PROJECT COMMENTS

DATE: 3/25/2021

PROJECT NUMBER: SP2021-008
PROJECT NAME: Site Plan for Rockwall Friendship Baptist Church
SITE ADDRESS/LOCATIONS: 5645 STATE HIGHWAY 276, ROCKWALL, 75032

EXTERIOR ELEVATIONS - BLDG 01

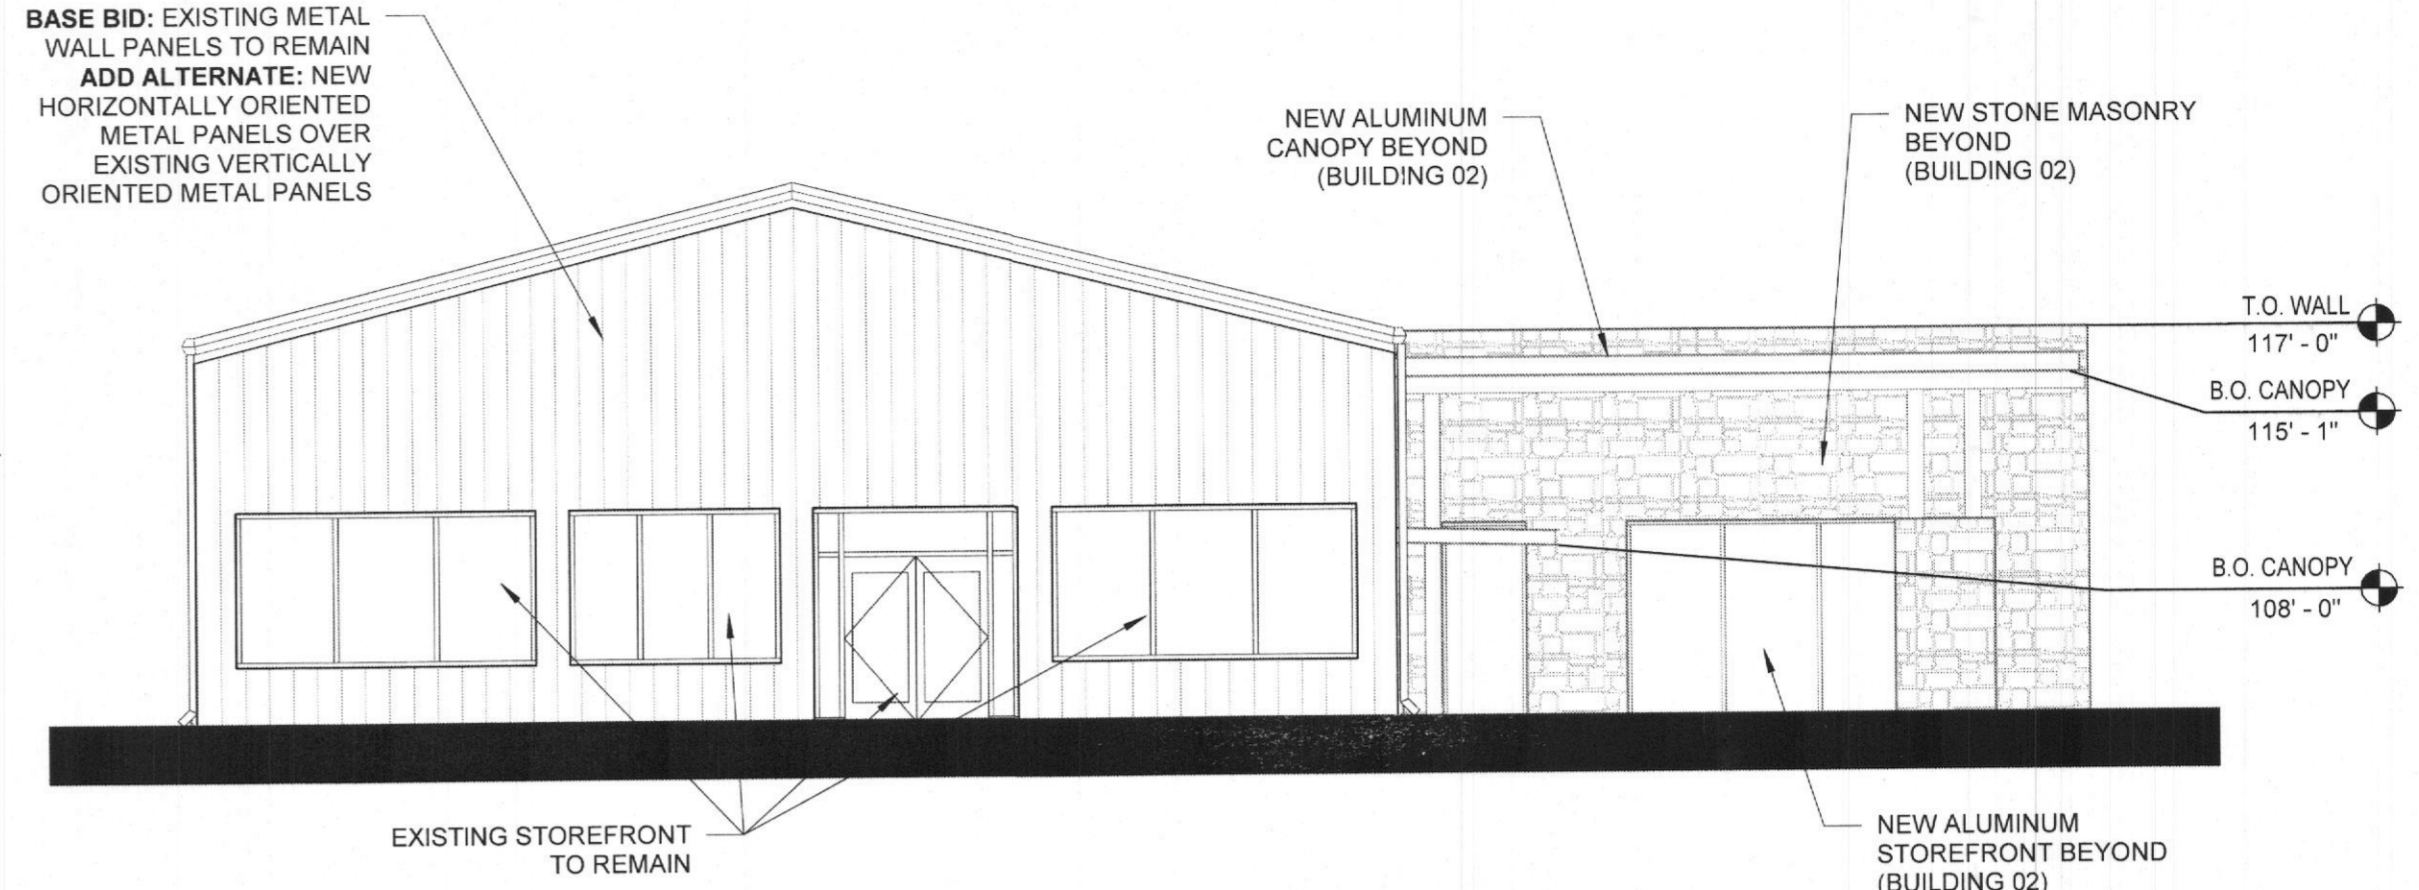
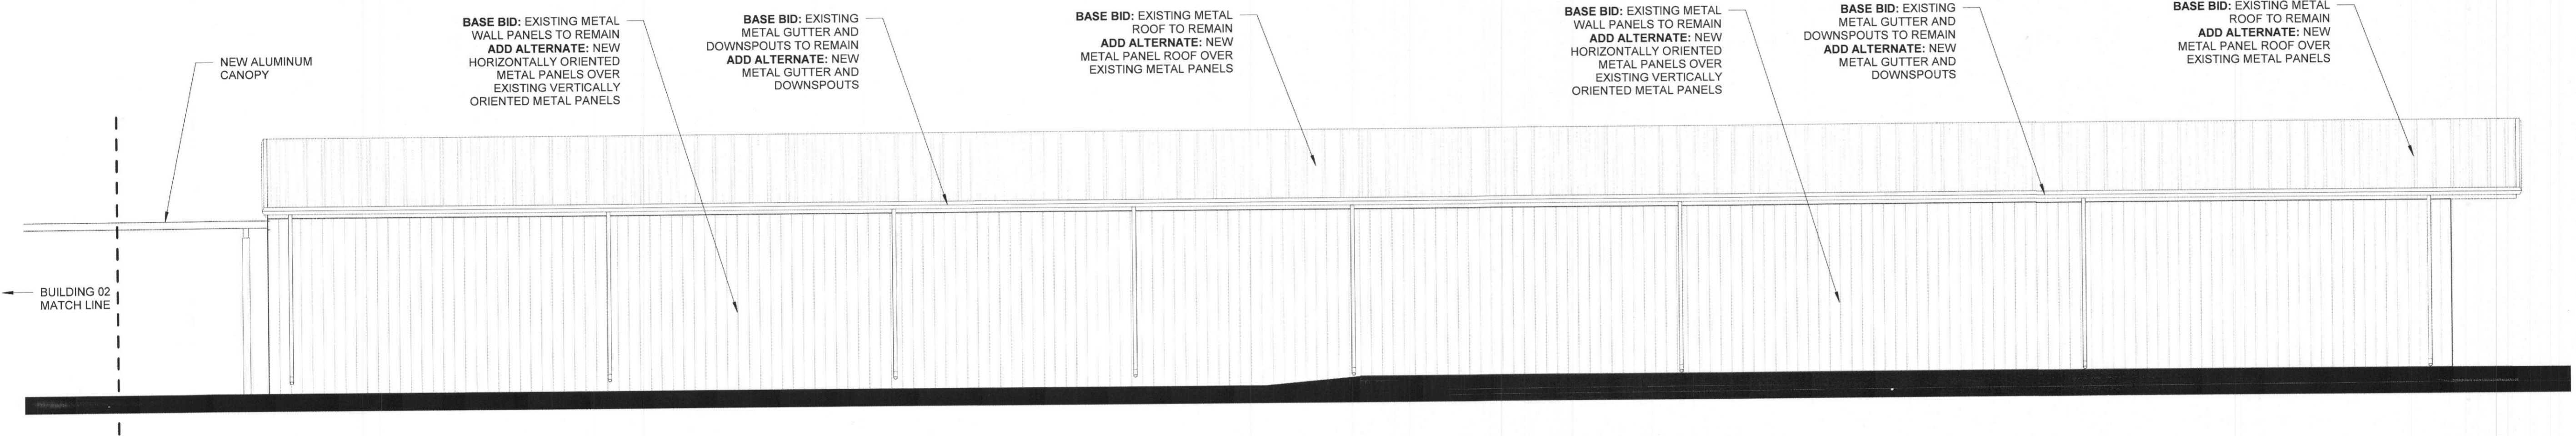
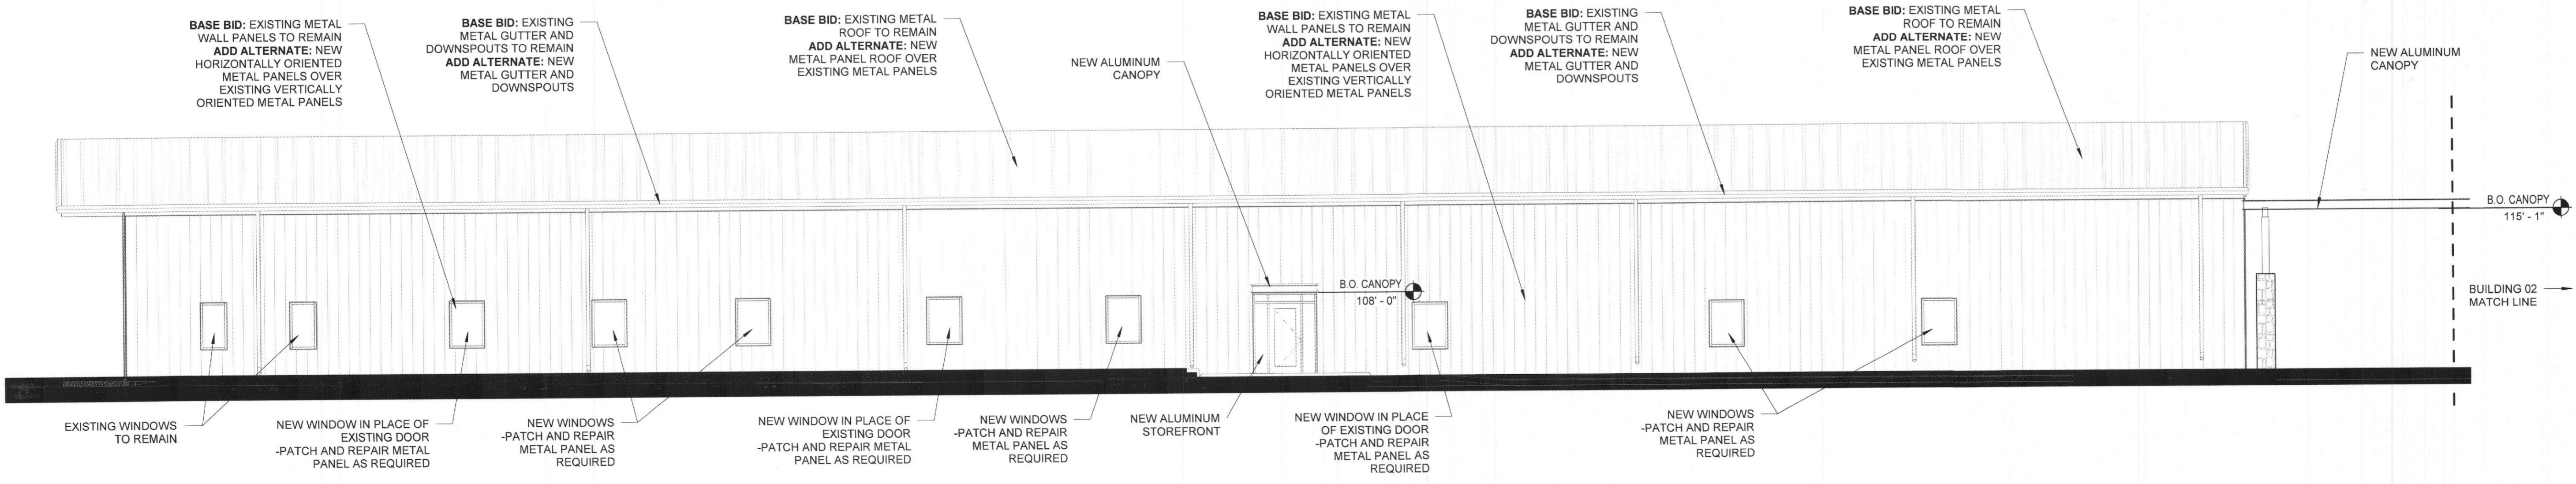
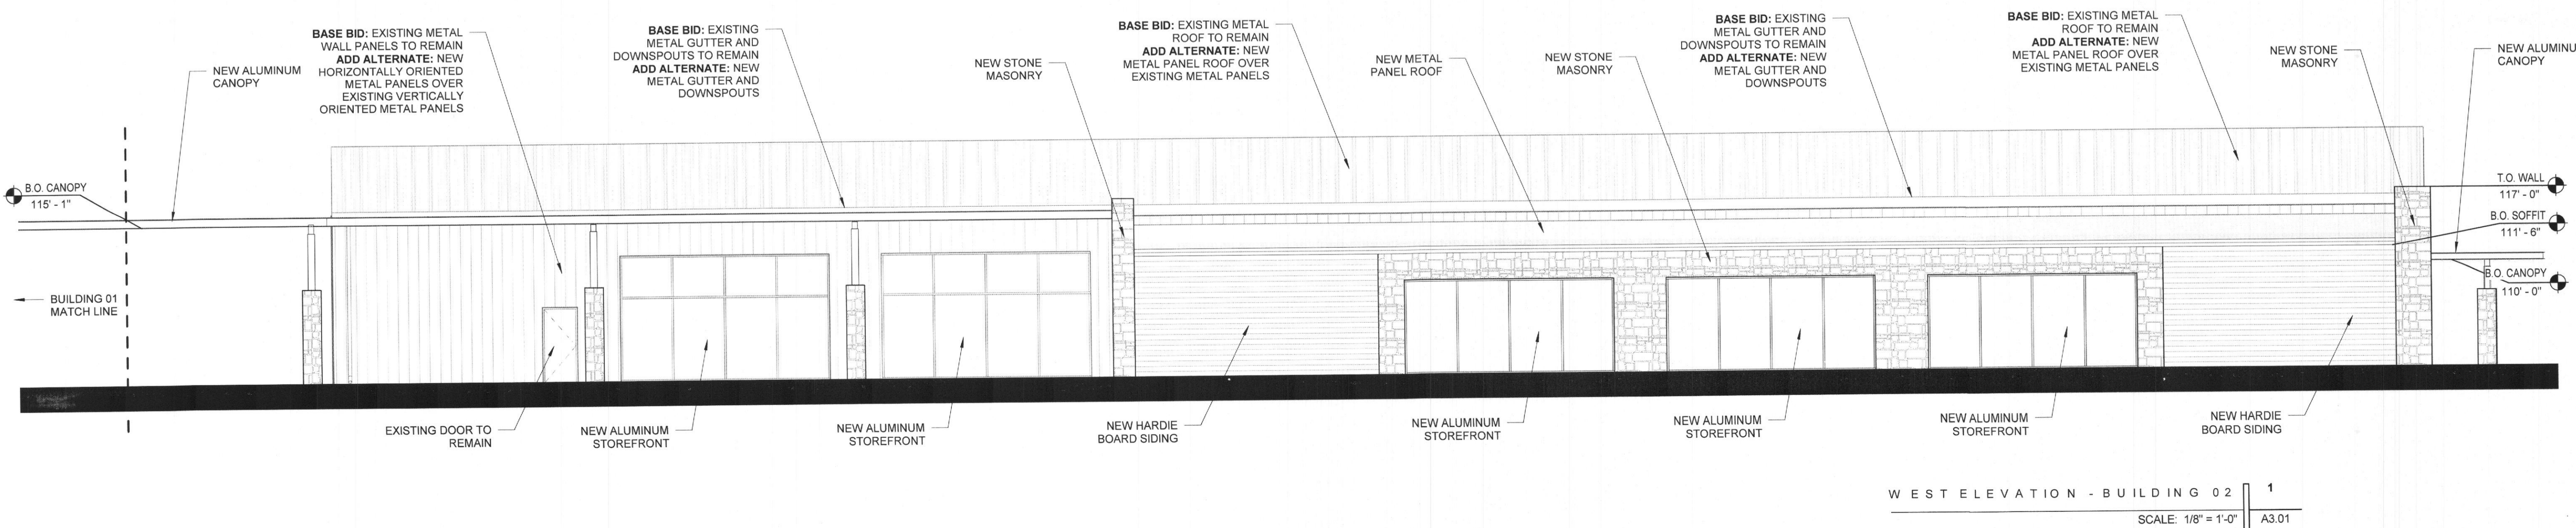
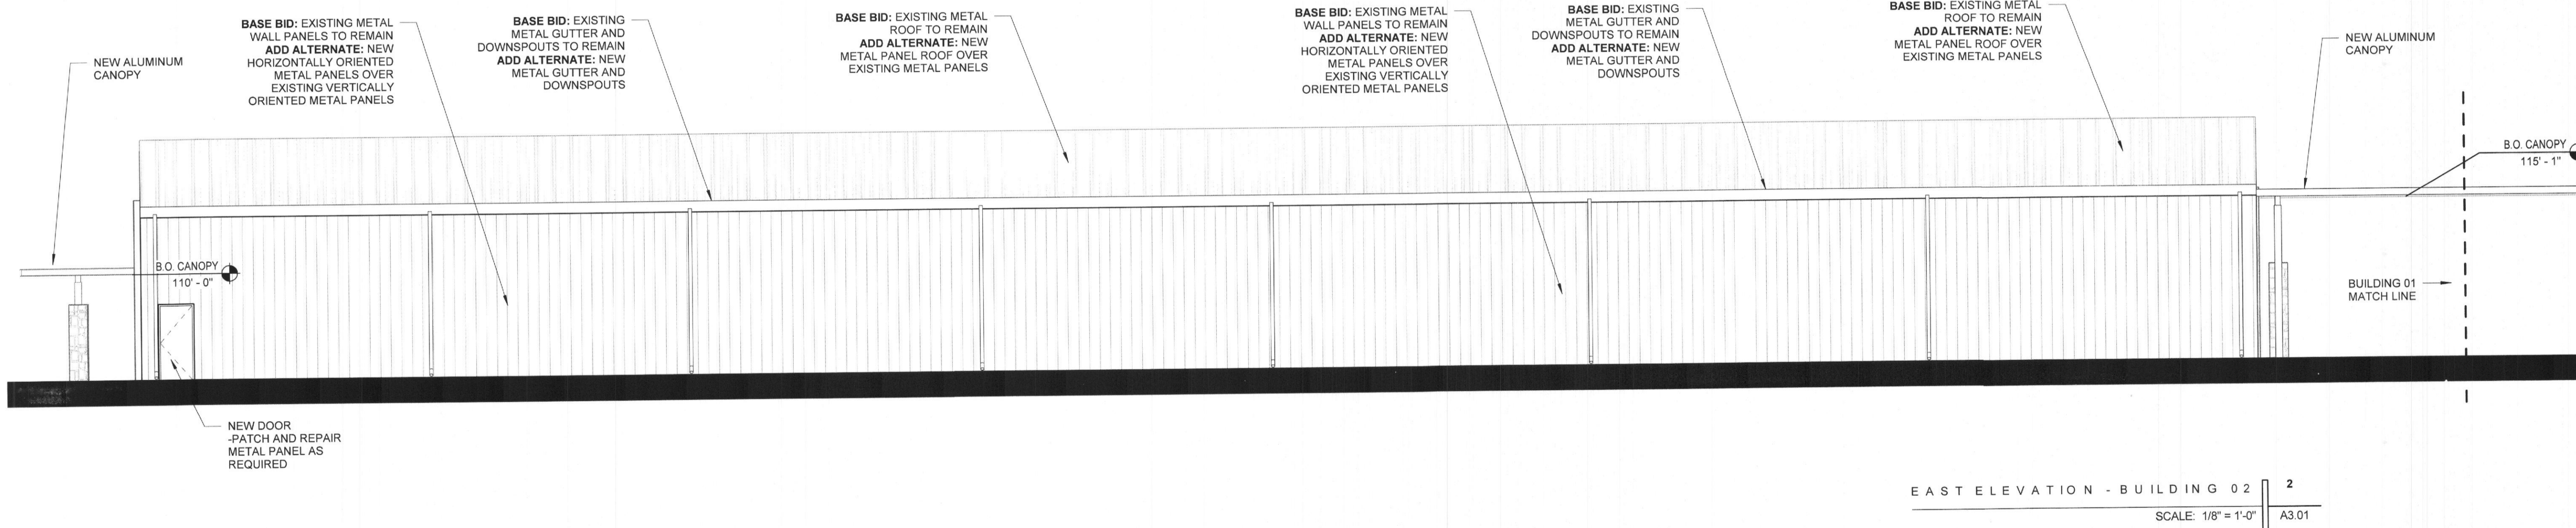
1. Each elevation must include a minimum of 90% masonry material; this would apply to the new addition. If this is not met on all sides of the proposed addition a variance would need to be requested and two (2) compensatory measures would need to be provided. (Subsection 06.02. C, of Article 05)

2. Indicate the surface area (square feet) of each façade and the percentage and square footage of each material used on that façade. (Subsection 04.01, of Art. 05)

3. Indicate any proposed roof mounted mechanical equipment and indicate how these will be screened from view. Consider crosshatching on the elevations where any roof mounted units will be located. (Subsection 01.05. C, of Article 05)

4. The proposed addition does not meet the horizontal articulation requirements. This would be a variance to the code requiring two (2) compensatory measures. (Subsection 04.01. C. A, of Article 05)
